Final Environmental Impact Report

231 Grant Educator Workforce Housing

SCH#2020120049

December 2021

Suitability for Preservation / Camphor #67

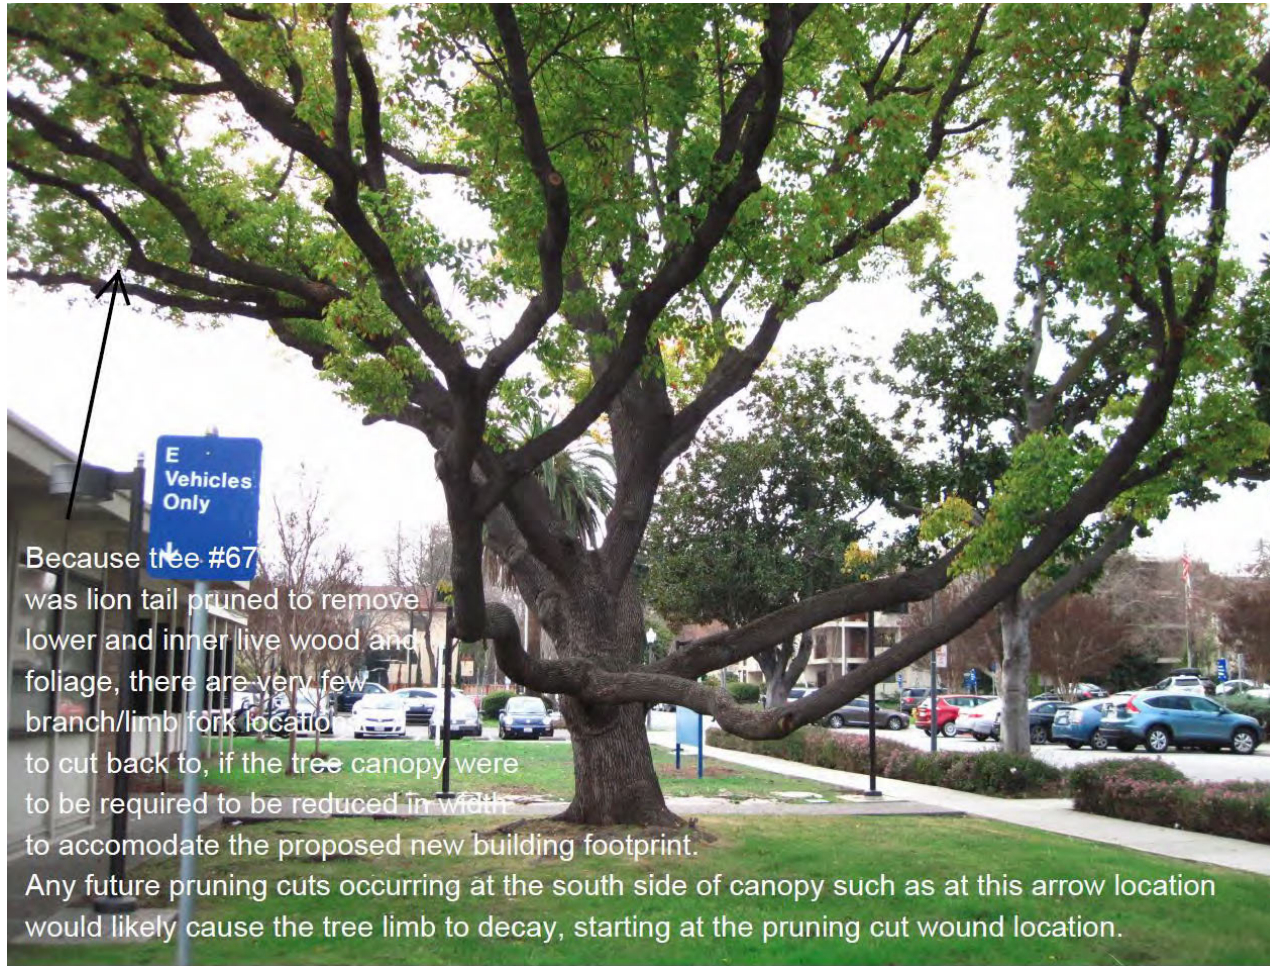
2.3.4 – Landscaping, Utilities, and Other Site Improvements – the original plans for this project called for mature trees to be preserved. Now you plan to remove more than half of the trees on the site, including two mature trees (#64 and #67) in violation of the County’s own Tree Protection Ordinance

Camphor #67 is another high water-use specimen, in poor overall condition. Similar to redwood #64, this tree is an older, larger specimen with large canopy dimensions that has suffered from the ongoing California drought and lack of regular heavy irrigation water applications.

This tree was also noted to have been subjected to “lion tail” pruning: a non-standard form of pruning that removes inner canopy and lower canopy elevation live wood and foliage, resulting in a pom-pom effect that encourages the tree to become lanky and over-extended, effectively increasing risk of limb and branch failure over time as the limb systems exhibit increased loads acting on their points of attachment to the lower mainstem. The tree has apparently been subjected to lion tail pruning multiple times, including during the last 12 months since WLCA’s initial tree assessment in early 2020.

As with redwood #64, the long term safe and useful life expectancy of the tree is limited, given that it is already in poor condition, and will be subjected to additional significant or severe root loss within the tree’s Critical Root Zone (calculated at 15 feet radius offset from trunk edge) and expected canopy loss due to proposed new building footprint work and also a construction corridor of an additional 5 feet width for travel by a lift machine in front of all of the building massings that requires additional clearance pruning to allow for exterior finish work to be performed. WLCA suggested to the project team that this high water-use tree in poor condition also be removed, based on the above factors.
